**Walton County  
The Grove**

**Change Proposal #3 –  
Monument Sign Scope Removal**

**Change Proposal #3 – Monument Sign Scope Removal**

SUBMITTALS / REVISIONS		
NO.	DATE	DESCRIPTION
C1	03/15/2024	CONFORMED SET

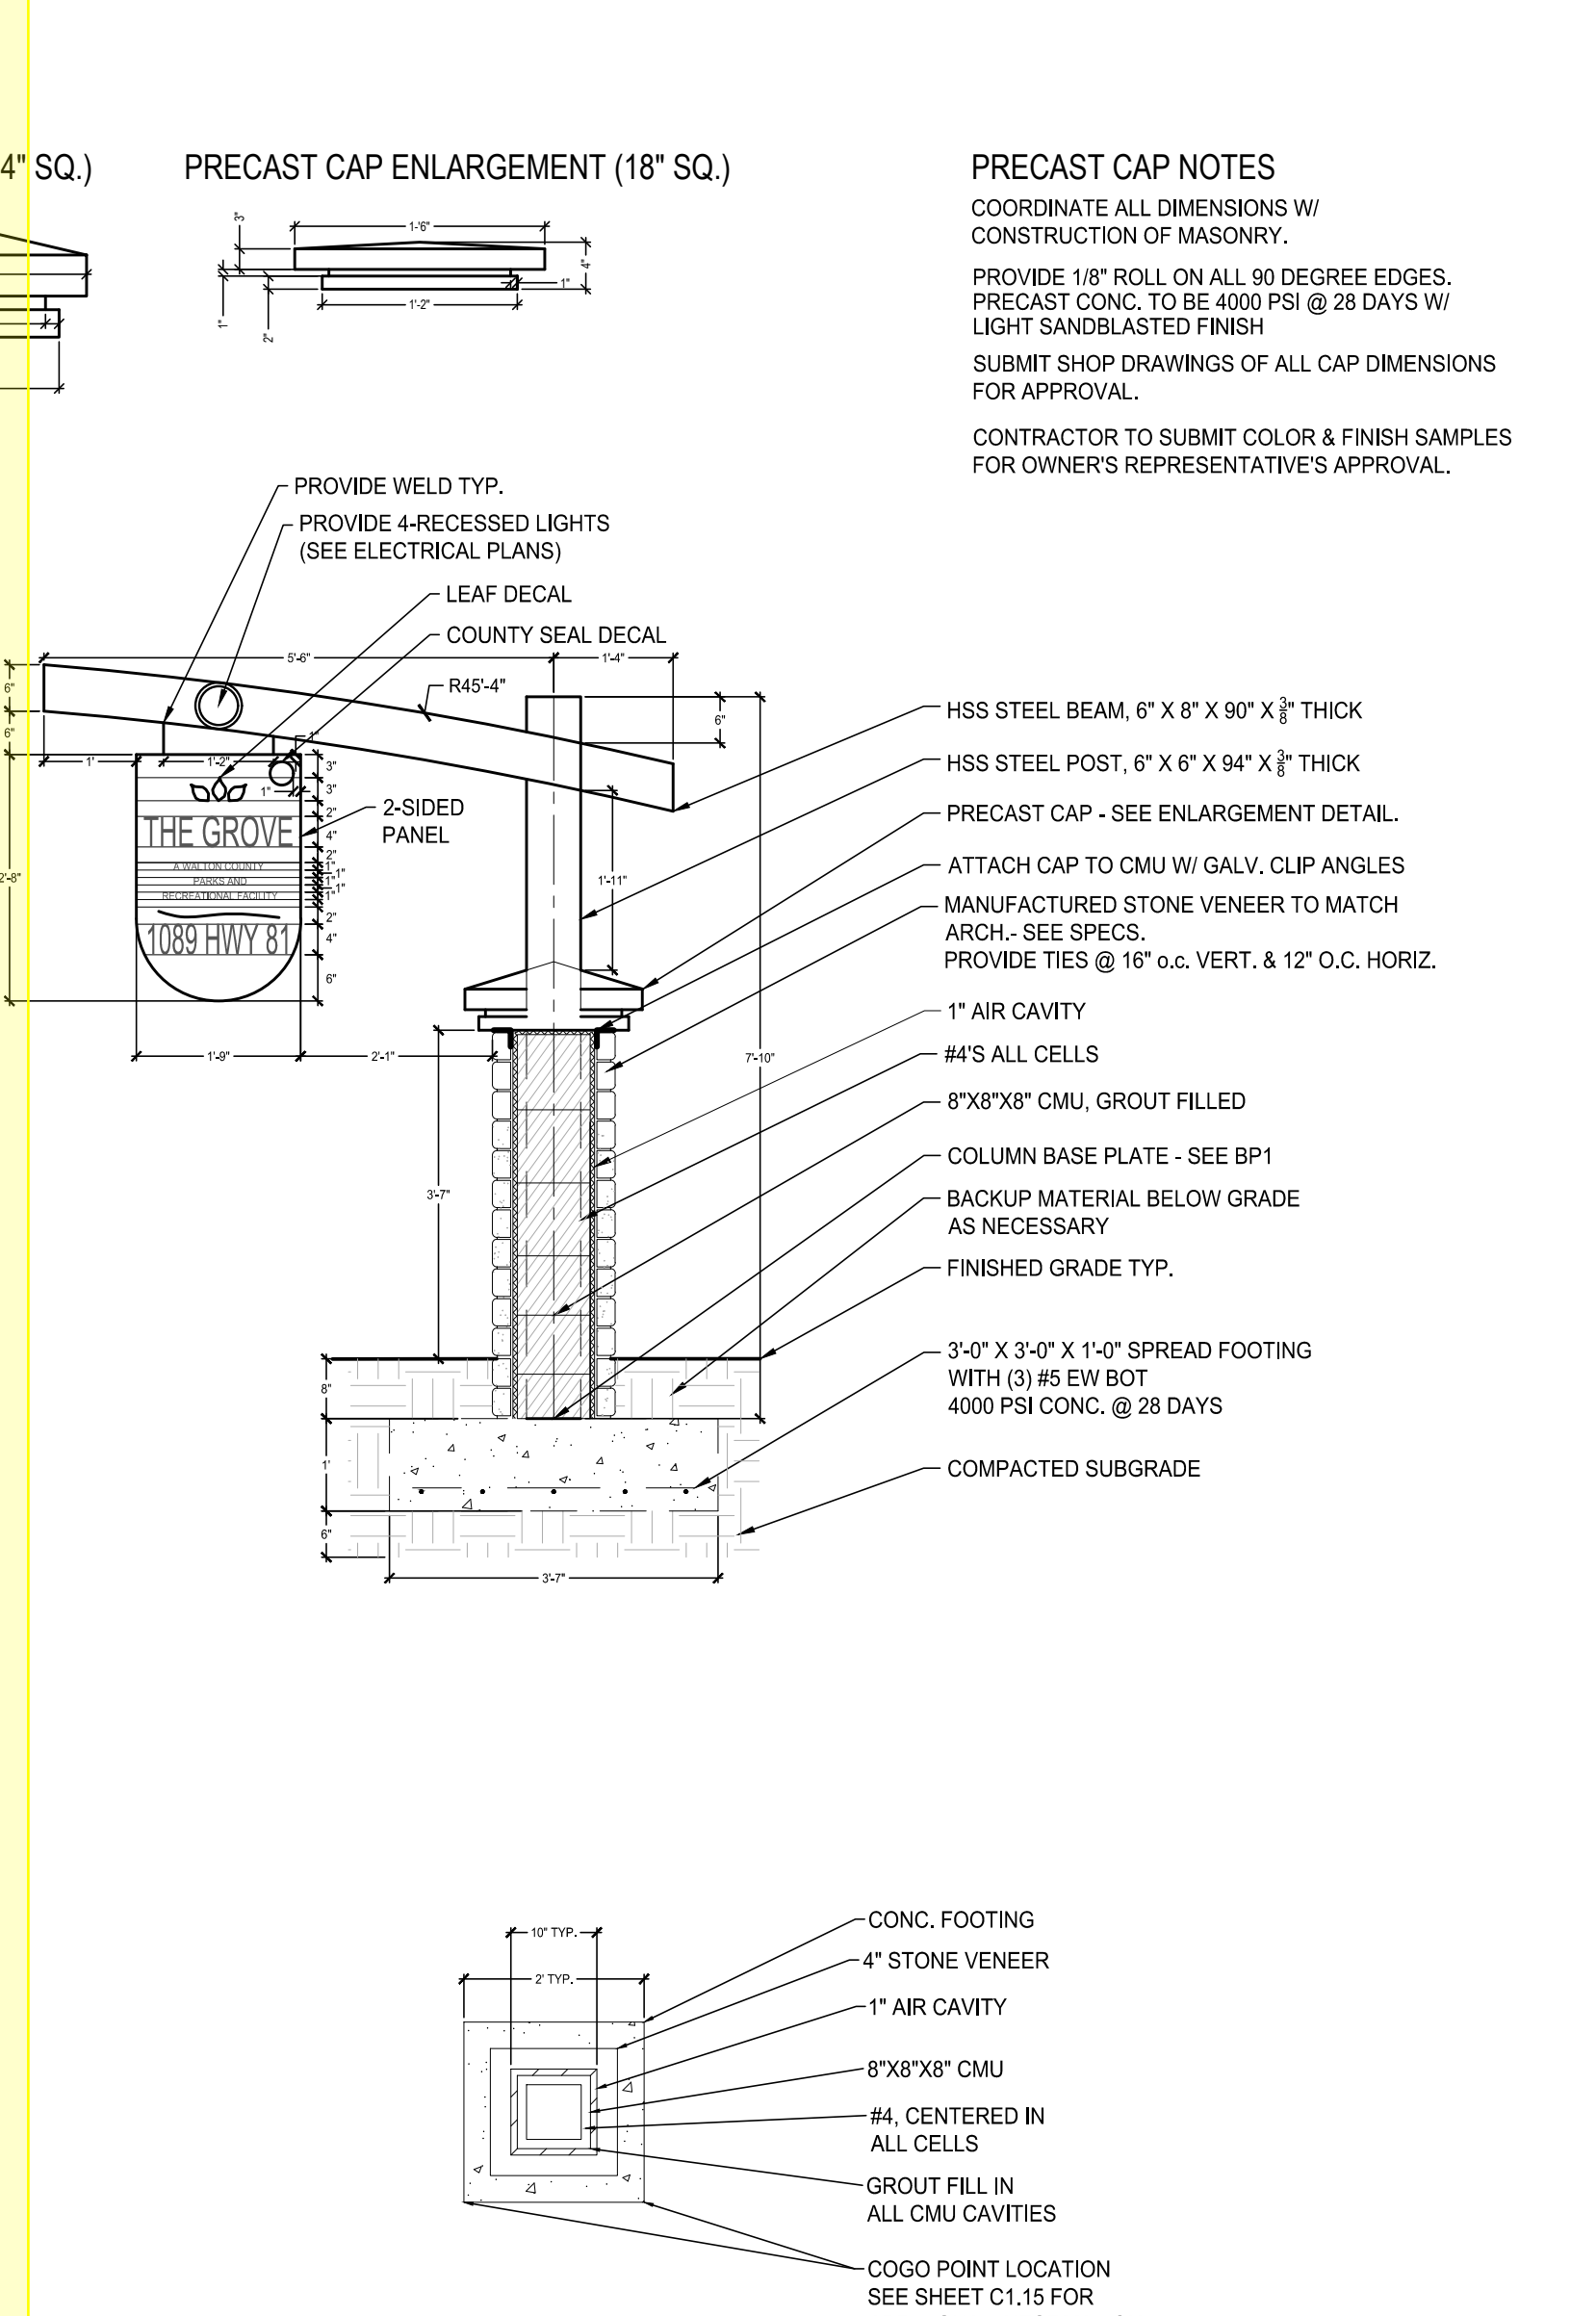
The below change proposal is for the material credit for the monument sign that was removed from RY’s SOW. Please see the breakdown and supporting documentation for your reference.

**DESCRIPTION: REMOVE CONCRETE & MASONRY AT ENTRY SIGN**
